STAFF RECOMMENDATION
1812 Fifth Avenue North
November 20, 2019

Application: New Construction – Infill and Outbuildings
District: Salemtown Neighborhood Conservation Zoning Overlay
Council District: 19
Base Zoning: R6-A
Map and Parcel Number: 08108027600
Applicant: Preston Quirk, Architect
Project Lead: Sean Alexander, sean.alexander@nashville.gov

<p>Description of Project: An application to construct a new two-story duplex and two single-story detached garages.</p> <p>Recommendation Summary: Staff recommends approval of the infill project with the following conditions:</p> <ol style="list-style-type: none">1. The finished floor height be consistent with the finished floor heights of neighboring historic houses, to be verified by MHZC staff in the field;2. Staff approve the front setback in the field after staking;3. Staff approve the masonry samples prior to purchase and installation;4. Staff approve the roof color, windows, doors, trim, porch floors, porch steps, porch railings, and parking pad materials for the infill prior to purchase and installation; and5. Staff approve the windows, doors, and roof color for the outbuildings prior to purchase and installation. <p>With these

ATTACHMENT A: PHOTOGRAPHS

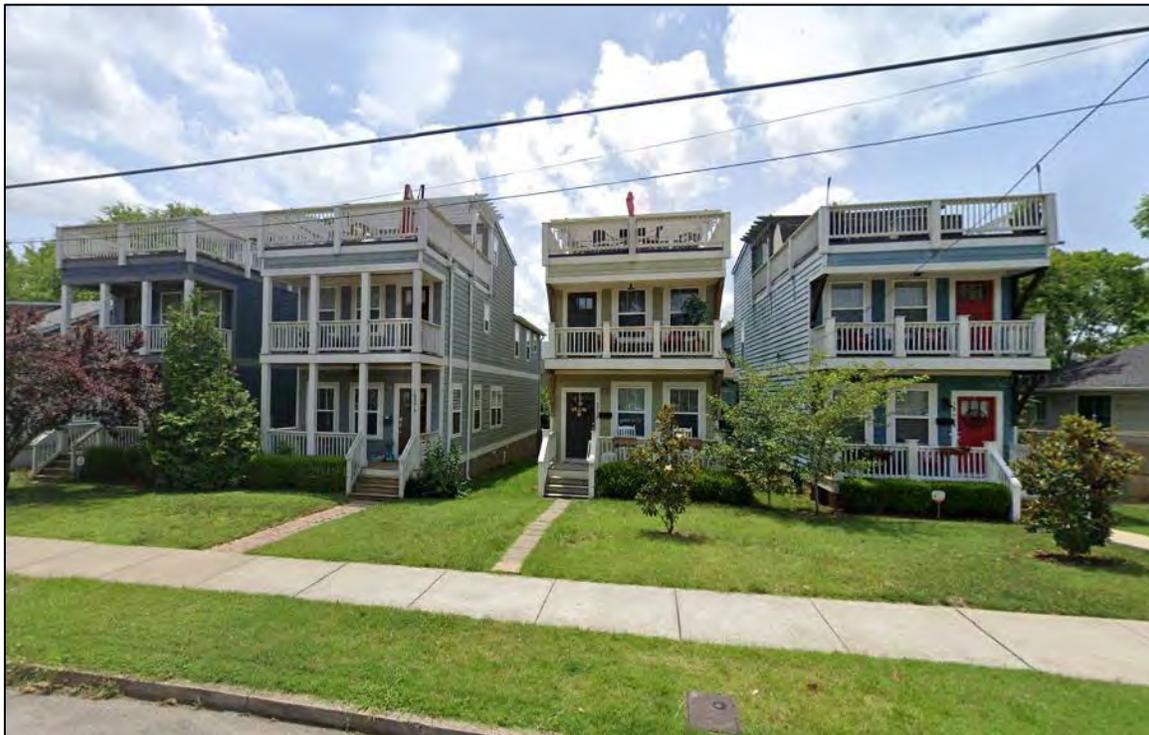
Two-story recent infill at 1816 5th Avenue North and historic one-story house at 1814.

Contributing buildings at 1808 and 1810 5th Avenue North.

1813 5th Avenue North, a similar design approved in 2015.

Non-contributing infill across the street at 1805, 1807, 1809, and 1811 5th Avenue North.

CARPORTS

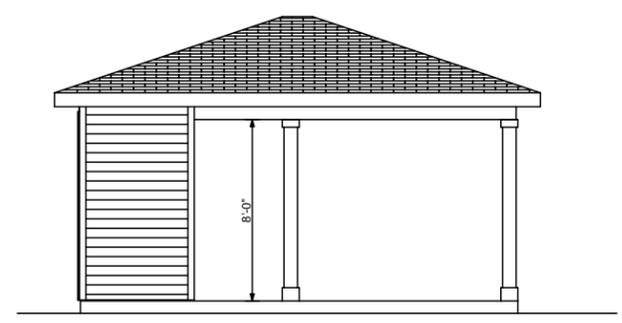
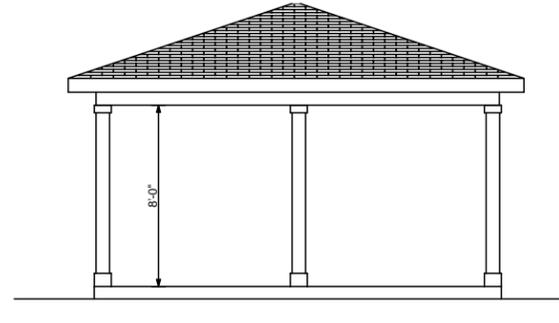
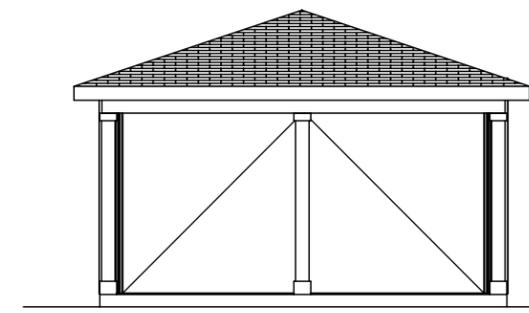
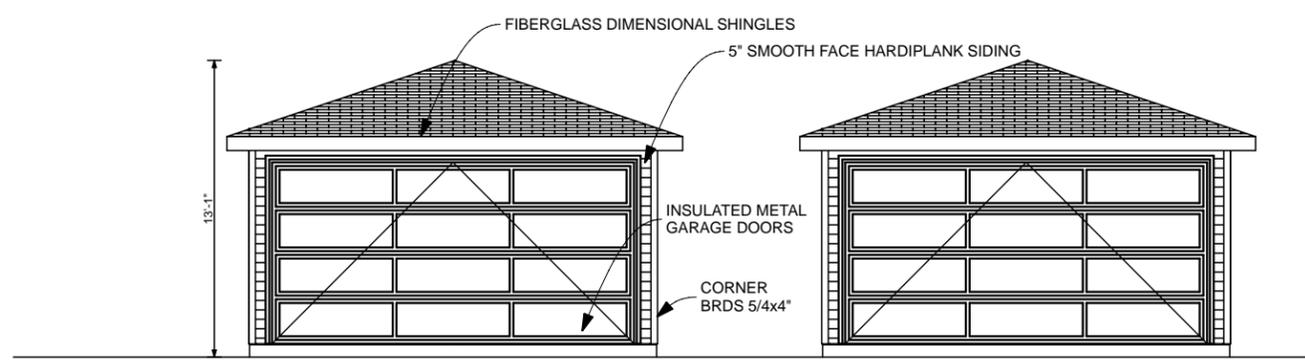
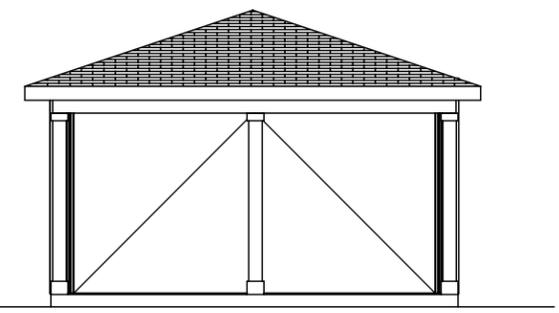
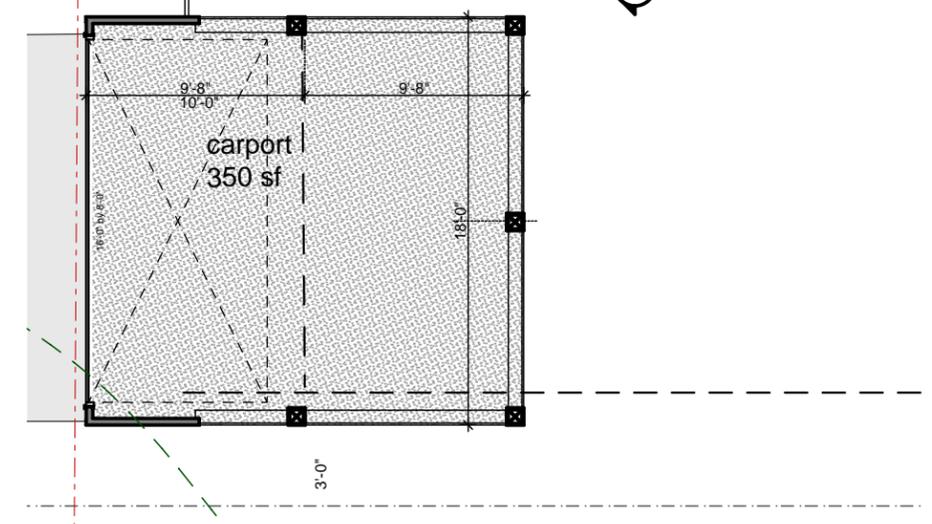
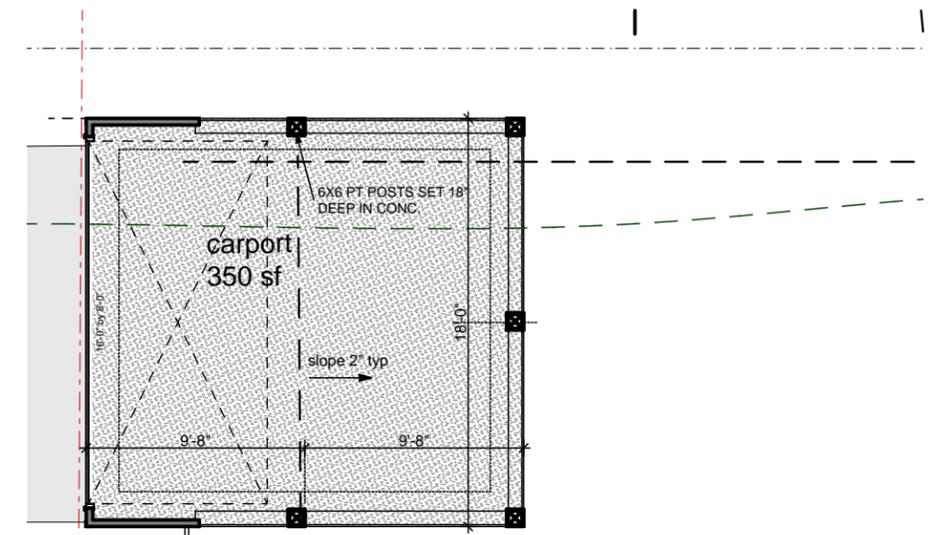
Outbuildings: The applicant is proposing two single-story outbuildings in the rear yard.

Potential Maximums for 1-Story Outbuildings Under the Salemtown Guidelines	Proposed Outbuilding
Ridge Height	25’ (not to exceed principal building height)	23’
Eave Height	10’	9’

Proposed Element	Proposed Form	Typical of district?
Primary form	Hipped	Yes
Primary roof slope	~ 4/12	Yes

The outbuildings are single-story, which is appropriate behind a two-story house. The outbuildings have a utilitarian design that is appropriate for an accessory structure. Staff finds that the proposed design meets Section III.H.2 of the design guidelines.

Proposed	Color/Texture	Approved Previously or Typical of Neighborhood	Requires Additional Review?
Foundation	Concrete slab	Natural	Yes	
Cladding	Cement-fiber Clapboard	5" reveal, smooth	Yes	
Roofing	Fiberglass shingles	Needs final approval	Yes	Yes

Trim		Wood and Cement-fiber	Smooth	Yes	
Vehicular Doors		metal	Needs final approval	Yes	Yes

With the staff’s final approval of the windows and doors, staff finds that the known materials meet Section III.H.4 and III.H.5 of the design guidelines.

Staff finds that the propose outbuilding’s height, scale, placement, setbacks, materials, and design meet Section III.H of the design guidelines.
